SUBJECT: NuScale Power, LLC Response to NRC Request for Additional Information No. 251 (eRAI No. 9188) on the NuScale Design Certification Application

NuScale Response to NRC Request for Additional Information eRAI No. 9188

NRC Question No.: 05.03.01-4

Figure 1

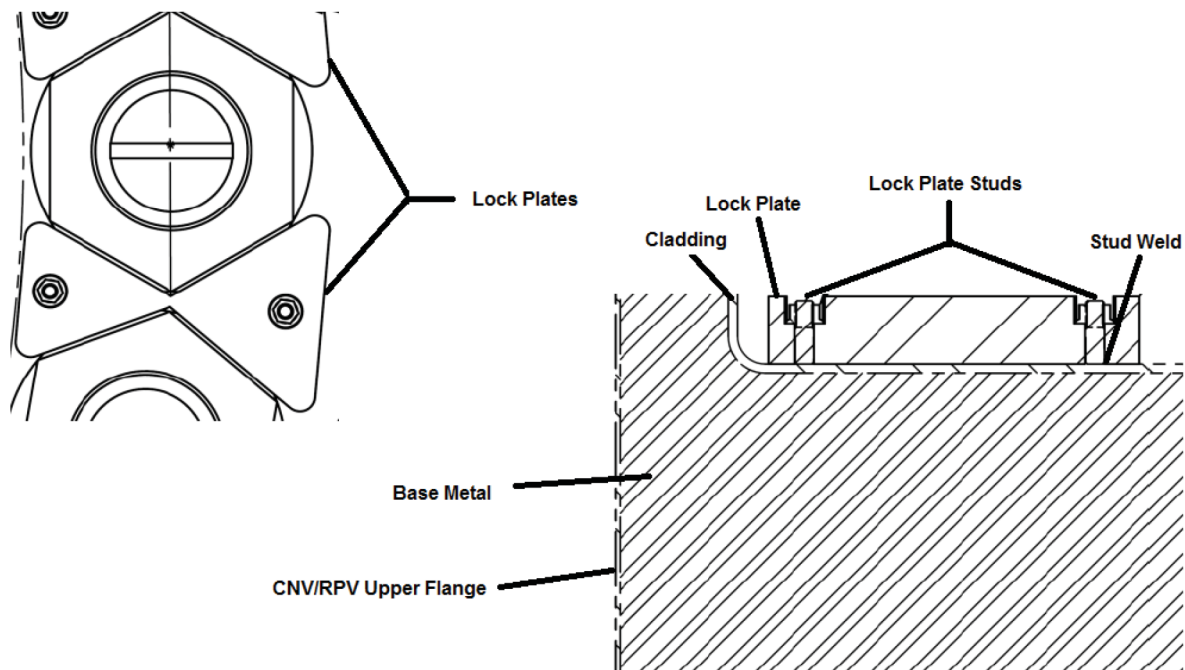
During the NRC staff's audit of DCD Tier 2, FSAR, Section 3.13, the staff reviewed the use of lock plates in the NuScale design. These components are not described in the DCD. However, based on information obtained during the audit, the lock plates are used to hold the RPV main flange studs in place to allow the fastener bolts to be inserted from below. The lock plates are connected to the top flange by two studs which are screwed into the top flange and have a weld around the stud into the flange.

The lock plate welds provide a corrosion barrier to the base metal. Therefore, degradation of these welds may cause degradation of the underlying base metal. Depending on their location, the lock plate welds may be subject to stresses during normal operation, refueling tensioning and de-tensioning, and ECCS actuation. The DCD does not discuss the installation and inspection (construction and inservice) of the welds. During the audit, NuScale stated that the lock plates are not intended to be removed on a regular basis (i.e., they are not going to be removed at every refueling).

- Revise the DCD Tier 2, FSAR, Table 5.2-4 and Section 5.3.1 to state the locations that the lock plate components will be used for the reactor coolant pressure boundary (RCPB).
 - Revise the DCD to describe the use of lock plates, including the welding procedures and inspections that will be performed on the lock plate welds during fabrication/installation.
 - Provide justification that the lock plate welds will not degrade during service. If justification cannot be provided, revise the DCD to describe augmented inspections to provide reasonable assurance that the welds will remain intact during operation.
-

The ½ inch diameter studs that retain the lock plates are now attached with a stud weld to the top of the cladding. The previous method of drilling into the base metal to attach the studs to the top flange has been eliminated from the design. For proper stud welding, the minimum thickness of the base material must be at least ¼ of the stud size. For this application the cladding is ¼ inch thick for the ½ inch diameter stud. These welds receive a liquid penetrant inspection at installation and subsequent in-service inspection per the regulatory requirements. Since the revised design welds the lock plate studs directly to the cladding, degradation of the of the stud weld will not degrade the CNV and RPV base metal.

The RPV lock plates are used for the studs and nuts that connect the Upper RPV Section Transition Shell Flange to the Lower RPV Section Flange Shell as shown on Figure 5.3-1. The CNV lock plates are used for the studs and nuts that connect the Upper CNV to the Lower CNV at the Refueling Flange as shown on Figure 3.8.2-1. Figure 1 below shows the revised lock plate design.

The RPV and CNV lock plates do not perform a RCPB function and serve only a tooling function to hold the flange nuts in place while stud torquing is performed. In addition, the current design eliminates the potential for RPV and CNV base metal degradation as the modified lock plate studs do not penetrate beyond the flange cladding. Therefore, no change to the FSAR is required as there is no safety function for the lock plates to describe or potential degradation mechanism caused by the lock plate studs to describe.
